SUBMITTAL TRANSMITTAL

September 27, 2011
WCM Submittal No: 11361-001.B

PROJECT: Harold Thompson Regional WRF
 Birdsell Rd.
 Fountain, CO 80817
 Job No. 2908

FOUNTAIN, COLORADO
HAROLD D. THOMPSON REGIONAL
WATER RECLAMATION FACILITY
SPEC. SECTION 11361 - CIRCULAR CLARIFIER
SLUDGE COLLECTION EQUIPMENT
MODEL "RSMTP" CIRCULAR CLARIFIERS
W.P.E. CONTRACT NO. Q10600A

SHEET NO.
5523-1

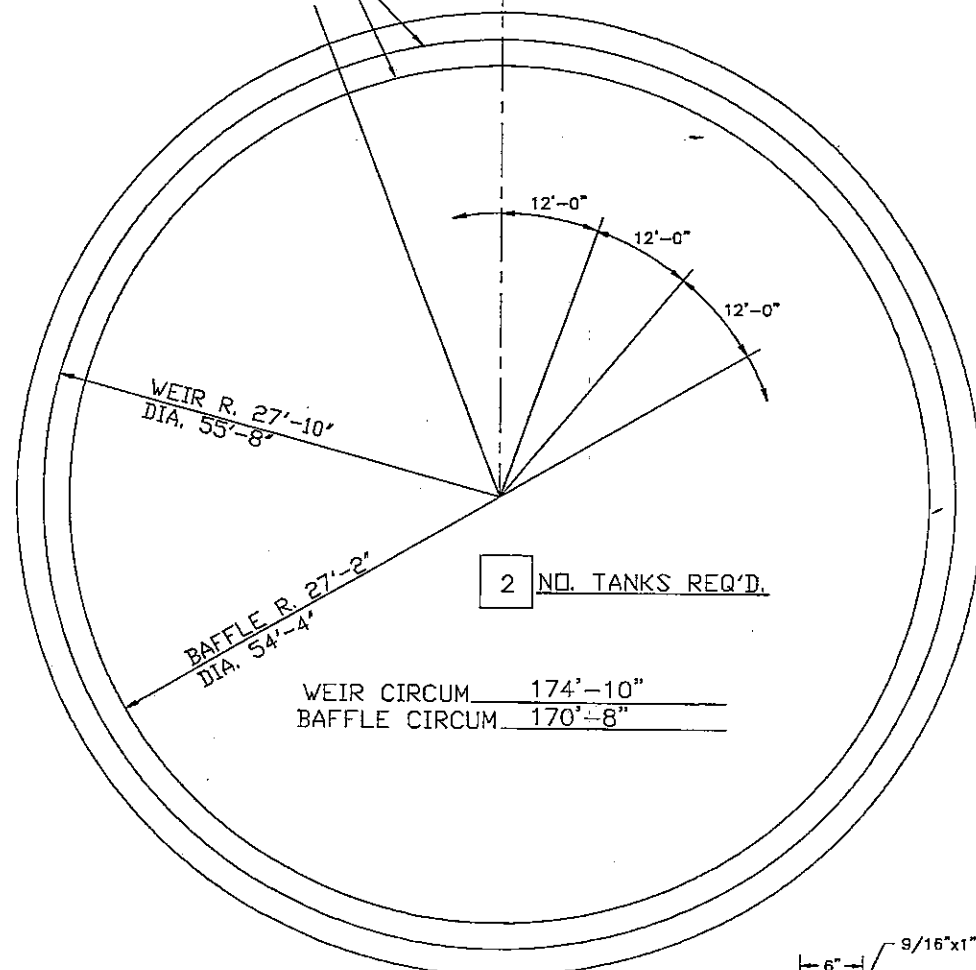
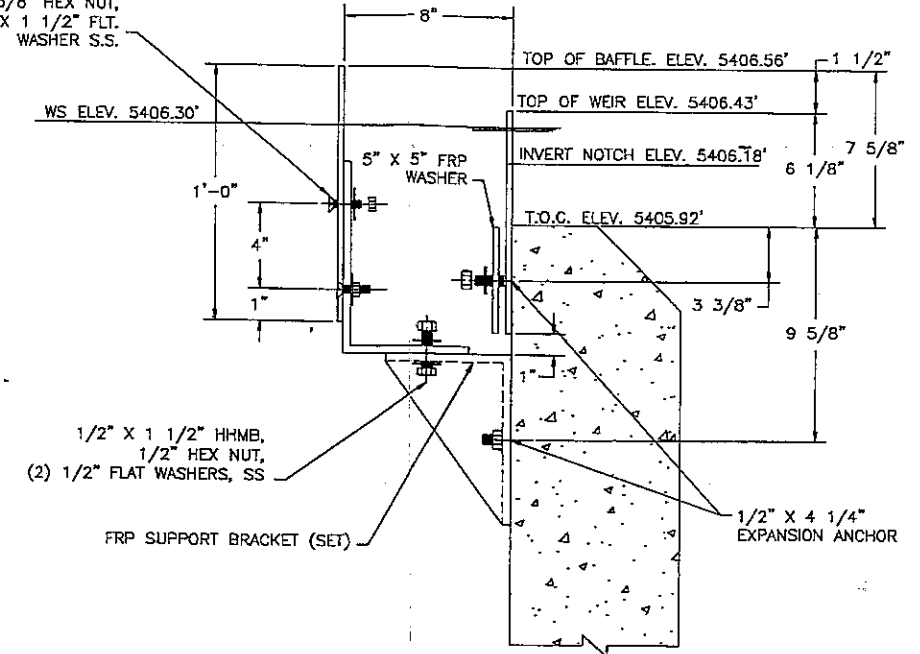
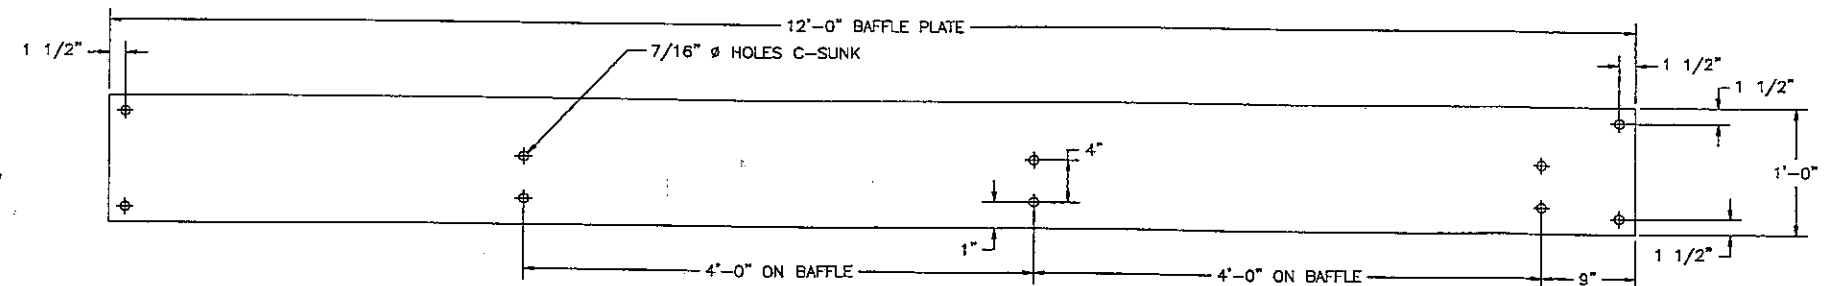
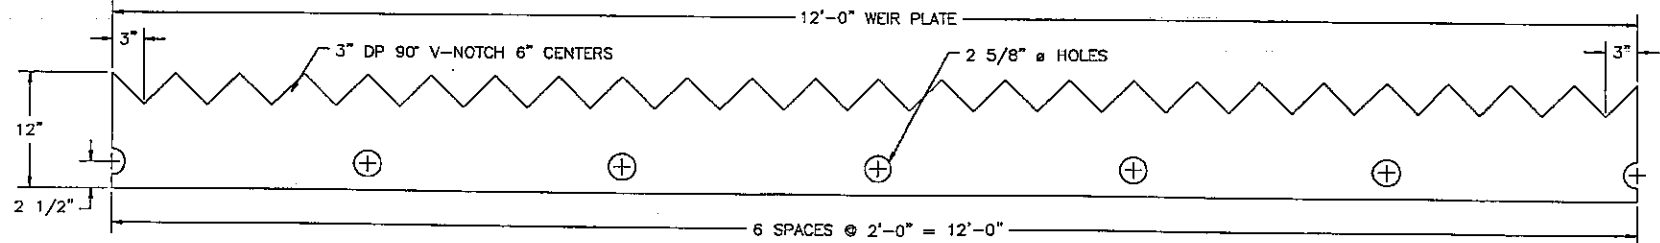
NO.	REVISIONS	DATE
1	REVISED PER COMMENTS	8-5-11
2	REVISED NOTCH SPACING	9-16-11
